SUBJECT: PEACH BOTTOM ATOMIC POWER STATION, UNITS 2 AND 3 - ISSUANCE OF AMENDMENTS RE: REVISE FACILITY OPERATING LICENSE AND THE TECHNICAL SPECIFICATIONS TO INCORPORATE ADMINISTRATIVE CHANGES (TAC NOS. MF4401 AND MF4402)

SAFETY EVALUATION BY THE OFFICE OF NUCLEAR REACTOR REGULATION

RELATED TO AMENDMENT NOS. 296 AND 299

PEACH BOTTOM ATOMIC POWER STATION, UNITS 2 AND 3

Figure 4.1-1 (page 1 of 1)
Site and Exclusion Area Boundaries

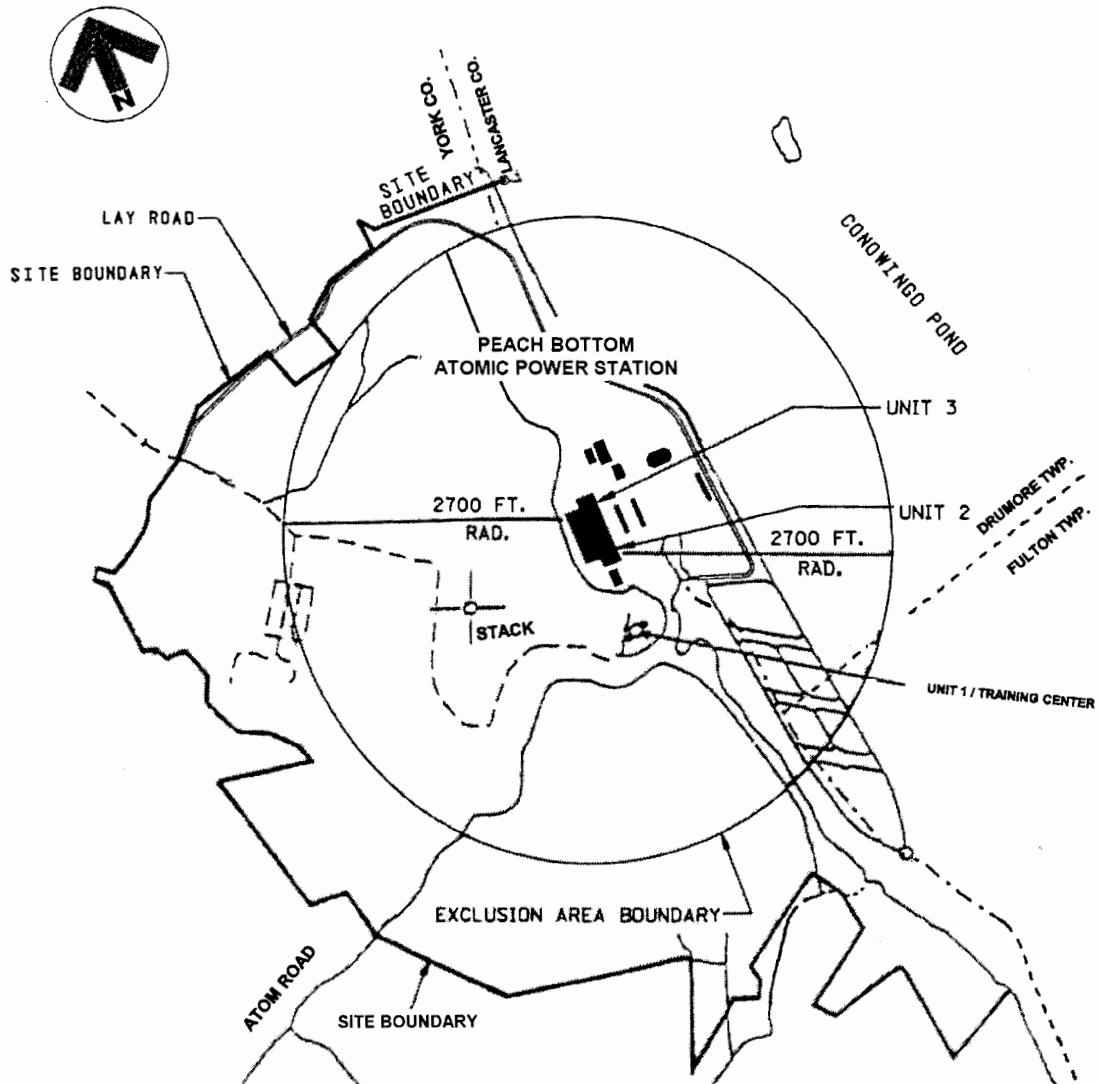
- 3) PBAPS Units 2 and 3, TS page 4.0.3: Figure 4.1-1, "Site and Exclusion Area Boundaries," would be revised to correct an error regarding location of a road and make other minor changes to more accurately reflect the current physical configuration.

The licensee's application proposed to revise TS Figure 4.1-1, "Site and Exclusion Area Boundaries," to correct errors and to make other minor changes to more accurately reflect the current site configuration. The revision would include correcting the details pertaining to the main access road in relation to the PBAPS facility. Additionally, the correction would include adjusting the details of the parking areas, correcting the access road within the Site Area Boundary (SAB), and changing the Susquehanna River label to Conowingo Pond. The route of the main access road has not physically changed, nor has the location of the SAB. Once within the SAB, the main access road runs along the bank of Conowingo Pond, as stated in the UFSAR. Therefore, for consistency, the name would be changed from Susquehanna River to Conowingo Pond. Extra lines that depict old parking areas would be removed from the drawing. In addition, railroad tracks that were in place during the construction phase of PBAPS, and have since been removed, would be deleted from the drawing. For clarity and consistency purposes, the licensee stated the correction of these items is appropriate.

The purpose of Figure 4.1-1 is to define the site and exclusion area boundaries. The NRC staff concludes that the proposed changes are appropriate since they more accurately reflect the current physical configuration. Therefore, the proposed changes to Figure 4.1-1 are acceptable.
